PUBLIC HEARING/WORKING SESSION MEMORANDUM

PETITIONS #26-20 & #27-20

355 and 399 Grove Street

Re: Riverside Station, Newton, Massachusetts
Sustainability Review Summary

Figure 7.3.1

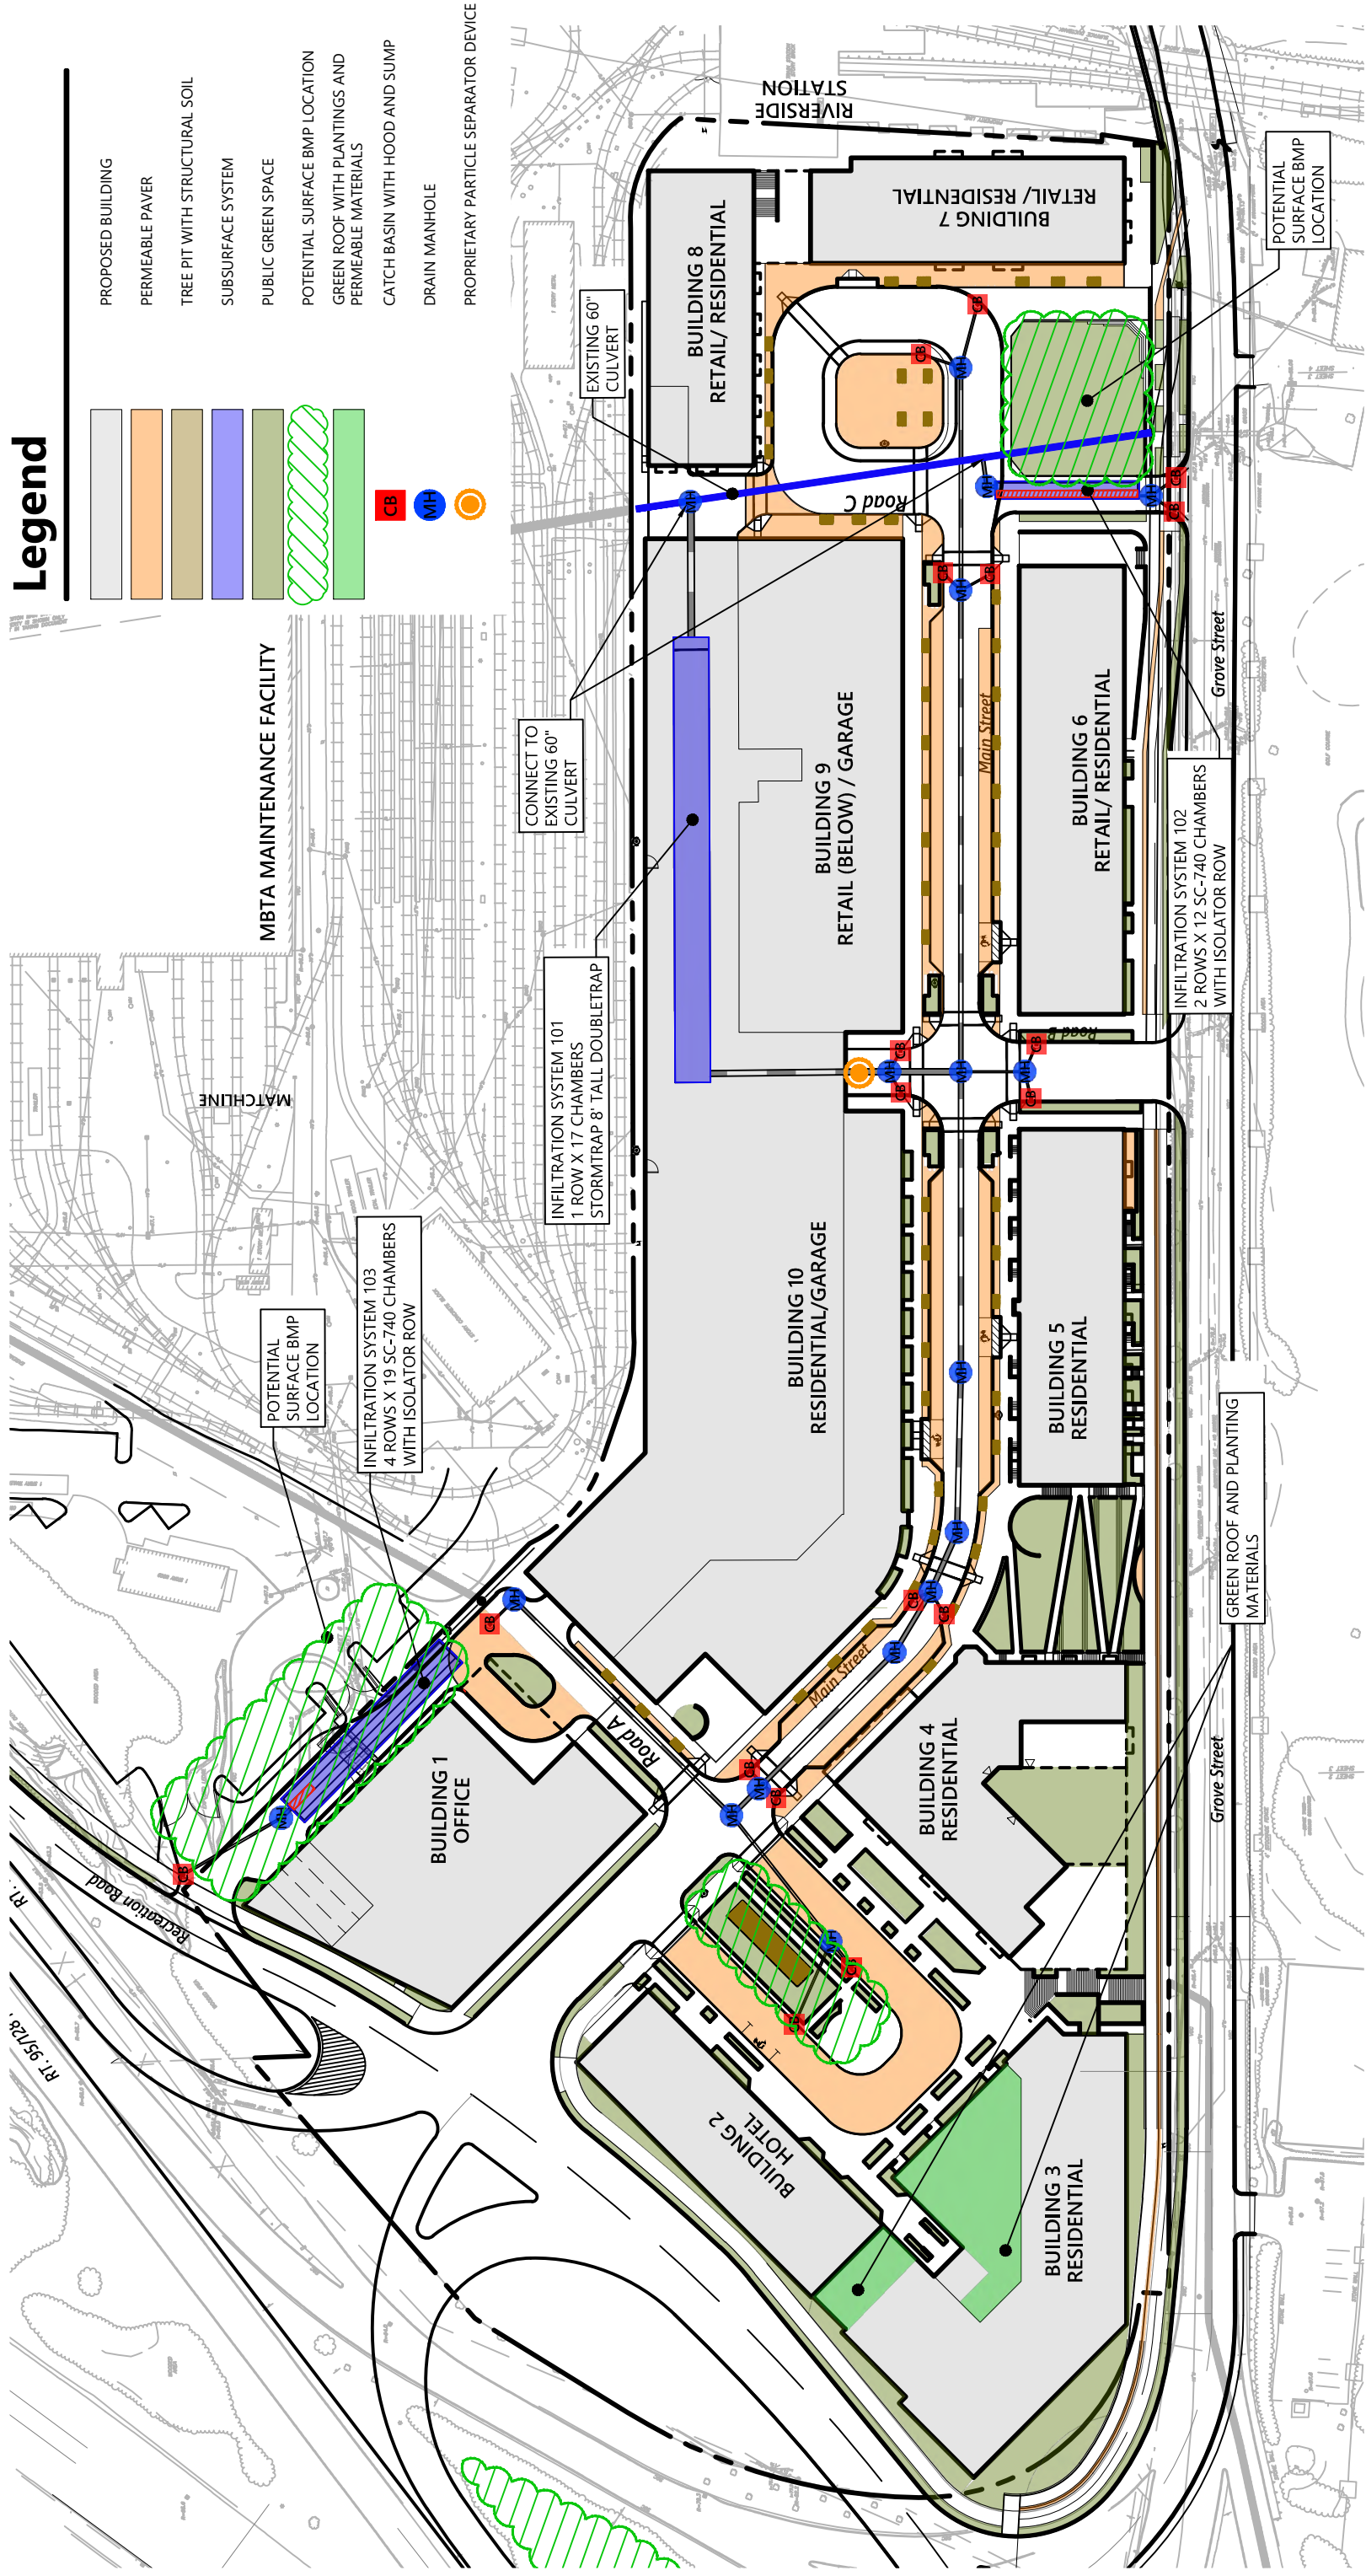
In response to Horsley Witten's comments, VHB stated that these types of infrastructure will be incorporated into the final plans, where conditions allow. The last page of VHB's response includes a conceptual plan indicating where each type of infrastructure will be installed. The Planning Department suggests that the revised plans include the type and location of this infrastructure.

The overall principles of the conceptual green infrastructure plan are:

1. Prioritize infiltration facilities where conditions are most amenable. Infiltration facilities maximize groundwater recharge and phosphorus reduction.
2. Divert runoff from sidewalks, bike path, and streets into permeable pavement and recharge facilities and bioretention areas integrated into the streetscape and transportation design.
3. Capture portions of the roof runoff in rainwater cisterns, to be used for landscape irrigation.
4. Maximize tree canopy, and support tree health by extending sand-based structural soil under the sidewalk adjacent to tree wells.
5. Design with maintenance and longevity in mind.
6. Reduce runoff volume and peak discharge rates to the municipal drainage system.
